From: [Hurley, Bobbie](#)
To: [Freeman, Carol](#); [Horton, Ruth M](#)
Subject: FW: Request for farmland conversion impact rating of Clinch River Reactor project
Date: Friday, October 16, 2015 8:43:13 AM
Attachments: [ClinchRiverSMRProject_AD1006_10_16_2015.pdf](#)

FARMLAND CONVERSION IMPACT RATING

PART I (To be completed by Federal Agency)		Date Of Land Evaluation Request 9/30/15			
Name Of Project Clinch River SMR Project		Federal Agency Involved Tennessee Valley Authority			
Proposed Land Use Small modular reactor (SMR) facility		County And State Roane County, Tennessee			
PART II (To be completed by NRCS)		Date Request Received By NRCS 10/8/15			
Does the site contain prime, unique, statewide or local important farmland? (If no, the FPPA does not apply -- do not complete additional parts of this form).		Yes <input checked="" type="checkbox"/>	No <input type="checkbox"/>	Acres Irrigated na	Average Farm Size 88 acres
Major Crop(s) corn	Farmable Land In Govt. Jurisdiction Acres: 19,476 % 8	Amount Of Farmland As Defined in FPPA Acres: 100,596 % 40		Date Land Evaluation Returned By NRCS 10/16/15	
Name Of Land Evaluation System Used LESA	Name Of Local Site Assessment System na

Figure 4. CRN Site Prime Farmland Soils

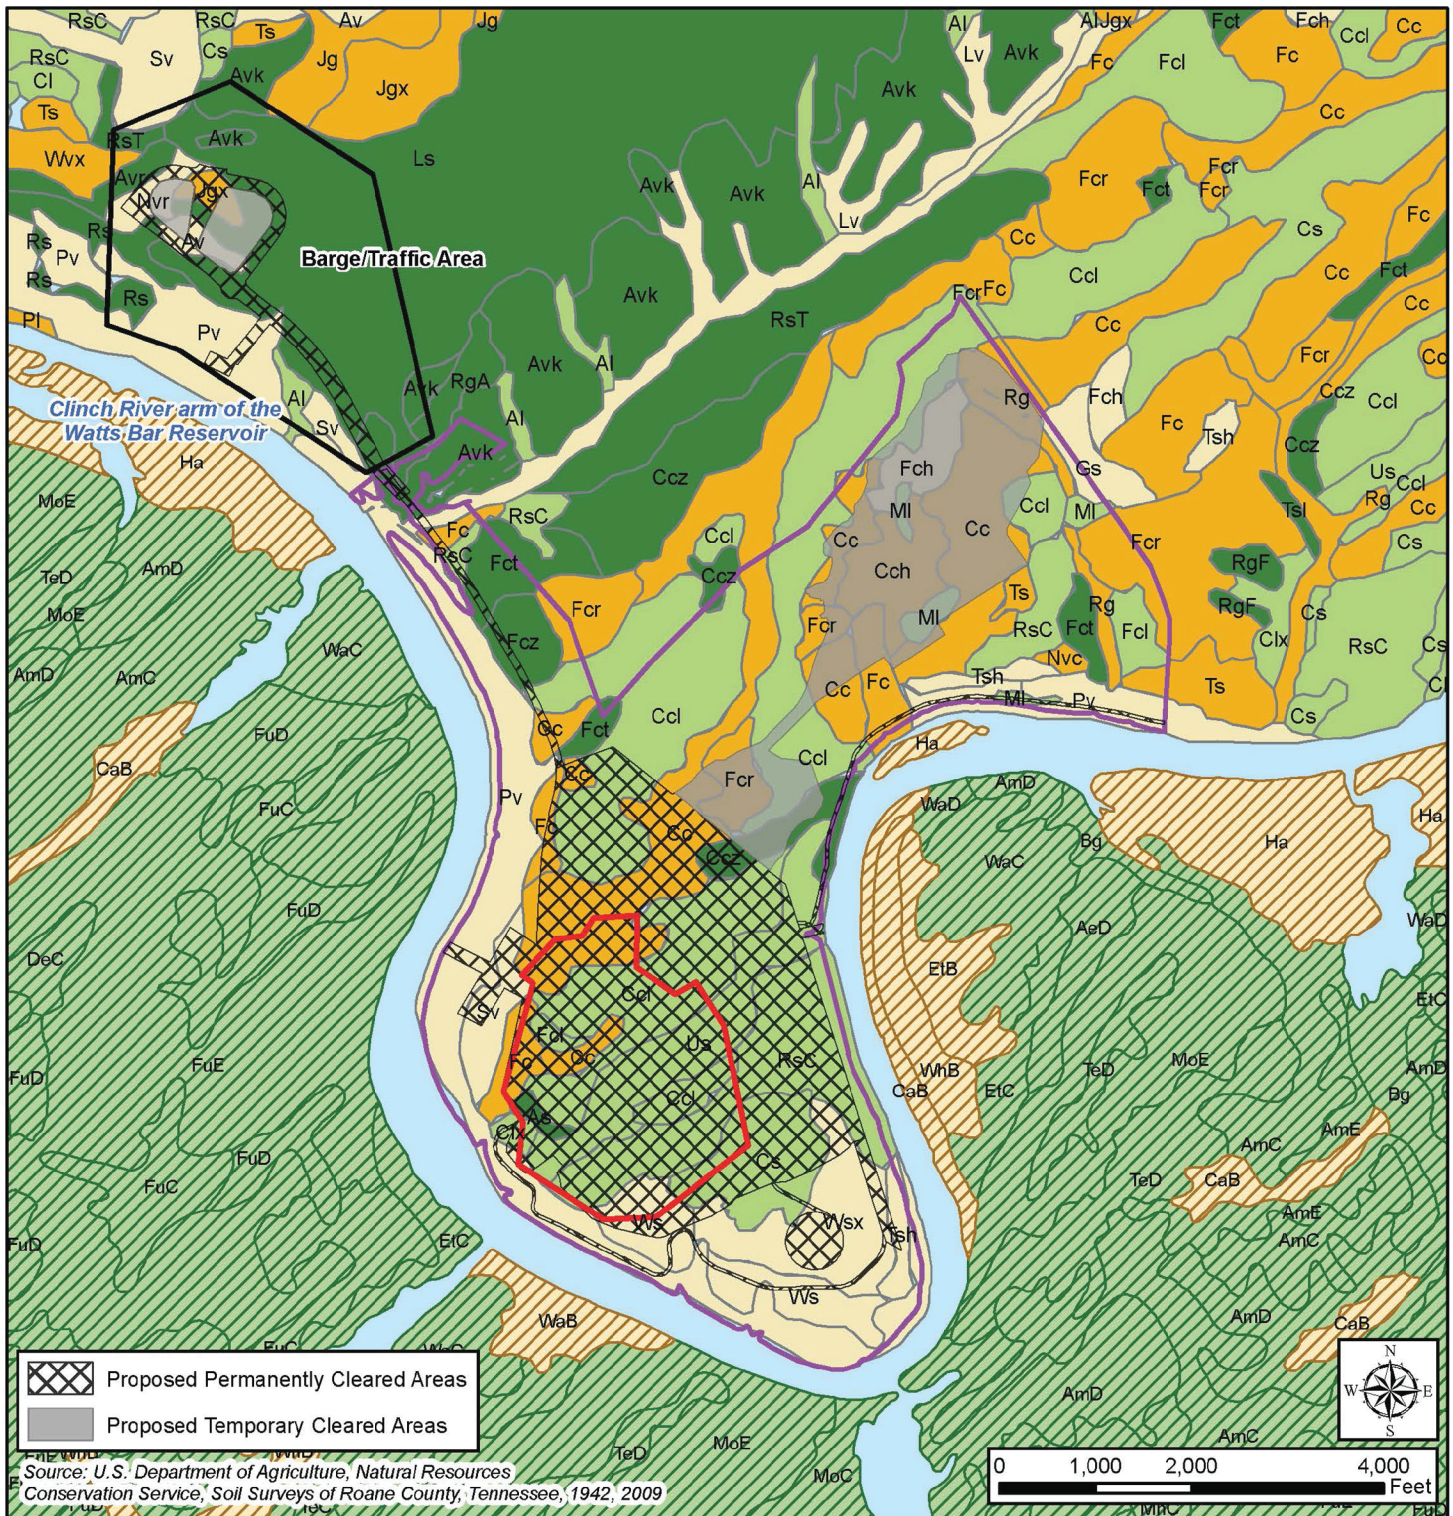
I received your request for Farmland Protection Policy Act (FPPA) review of the Clinch River Reactor project and I need to get a little more information that was not in the documentation that I had forwarded to me. On the enclosed AD-1006, you have listed that the entire 1131 acres will be converted and I wanted to make sure this was correct or is the area that was manipulated in 1983-1984 the area that will be impacted by the overall project (240 acres).

Thank you for your review. Approximately 328 acres would be permanently converted within the

CRN Site, including the entire 240-acre area previously disturbed during the CRBRP. An additional approximately 140 acres within the CRN Site would be temporarily converted as a result of construction activities, mostly to the northeast of the main plant site. Within the offsite Barge/Traffic area approximately 30 acres would be permanently converted (of which approximately 12.1 acres have been previously disturbed) and an additional 15 acres would be temporarily converted. Overall, the entire 935 acres of the CRN site would be unavailable for use as farmland because the site would be restricted access. Much of the Barge/Traffic Area is DOE property that already has restricted access. Attached is a new Figure 4 that shows the permanently and temporarily cleared areas. The GIS files for these are also included for download in the link below. If you need additional information please let me know and we will be happy to assist.
